PREPARED FOR THE PLAN COMMISSION

**Project Address:** 425 West Washington Avenue (District 4 - Ald. Verveer)

**Application Type:** Conditional Use Alteration

**Legistar File ID #** [38151](#)

### **Privacy Fence and Upper Story Railing (Items 1A and 3A)**

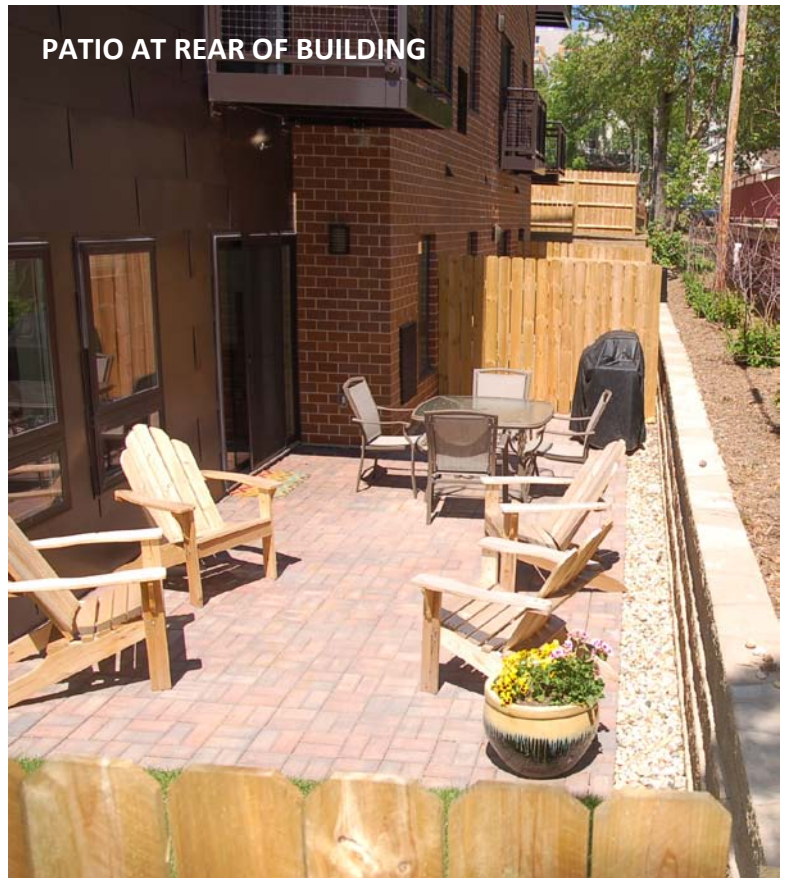
The installation of the wooden privacy fence is believed to be more of a suburban residential character and less appropriate in character for this site. Similarly, the Planning Division has concerns on the appearance of the wooden roof-top railing, which is relatively visible from the street. While having this railing is a building code requirement, it is not required to be designed in its current form that was never reviewed by staff. The existing railing is also believed to be too residential and suburban in character. Should these have been submitted for staff review, staff would have recommended alternative designs be pursued.

At the rear of the property (see right photo), a previously approved landscaped area has been constructed as a hard-scaped patio area for tenants. The area is covered with brick pavers. While this provides a nice tenant amenity, the Zoning Administrator has requested confirmation statistics that the project still can meet the required lot coverage requirements. The zoning code requires that lot coverage not exceed 90%. That includes buildings, accessory structures and all paved areas (with the exception of sidewalks no wider than five feet). The lot coverage requirement cannot be waived by the Plan Commission. A condition of approval is recommended that the applicant provides calculations showing code compliance.

**HVAC Wall Vents**

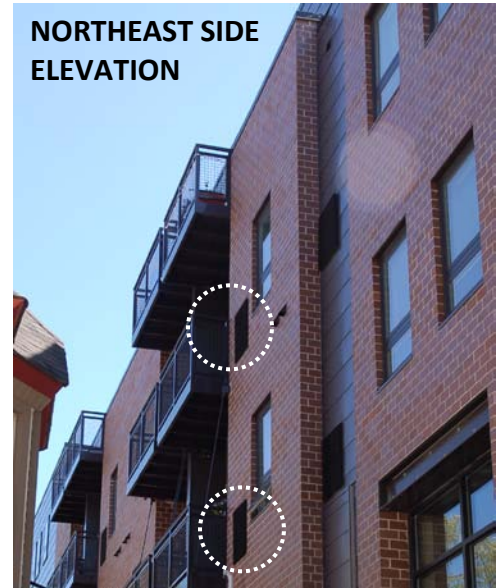
The Planning Division believes the most significant alteration relates to the revised HVAC vent locations. Plans originally had most of these vents located within balcony recesses. As noted in the below table, a majority of these have been relocated to outward-facing walls. In addition, the applicant notes that an additional HVAC vent was required to serve the commercial space. A summary of relocated vents is below:

The new and relocated vents are labeled as “2A” and “2B” on the applicant’s attached plans. The applicant states that these vents did not fit within the allowed balcony space and had to be relocated. At the time of report writing, the applicant has not shared what the cost implication would be to reconstruct these features in accordance with approved plans. Staff is also providing copies of the approved elevation drawings in the Commission’s materials. Unless specifically depicted, the HVAC vents were previously represented to be located within balcony recesses. In the below photos, examples of the non-approved, outward-facing vents are circled.

Staff notes that while there are multiple relocated vents on the building’s sides and rear, none have been added to the front façade. The front façade is clearly the most visible façade. In staff’s opinion, the northeast side of the building has limited visibility from the street. The southwest side, adjacent to the five-story office building is currently more visible due to orientation of that site. The Downtown Plan identifies this site as a “Potential Redevelopment/Infill Site” though there are no known plans to redevelop that property at this time.

This project was approved with an additional “bonus” story. As such, the “excess height” standard applied to this project and required a finding that the excess height allows for a demonstrated higher quality building than could be achieved without the additional stories. The Planning Division believes that aesthetically, the project better aligns with that standard as previously approved. Similarly, the Downtown Plan recommends that additional stories are to be used as a tool to encourage and reward buildings of truly exceptional design that respond to the specific context of their location and accomplish specific objectives defined for the area. The Planning Division would have recommended these vents be relocated should they have been presented like this in original plans.

The Planning Division does not believe that the standards for conditional uses are met and recommends that the Plan Commission **Place on File** the requested alteration for the relocated HVAC vents (identified in the applicant's materials as alteration "2A.") The Plan Commission is required to state the findings of fact listing the standards that have not been met and the reasons such standards(s) were not met. The Planning Division does not believe Conditional Use Standards 4, 9, 14 are met with this requested alteration. Alterations regarding the roof-top guard rail and wooden privacy fence (1A and 3A in the applicant's materials, respectively) should be carefully considered carefully against the standards.)
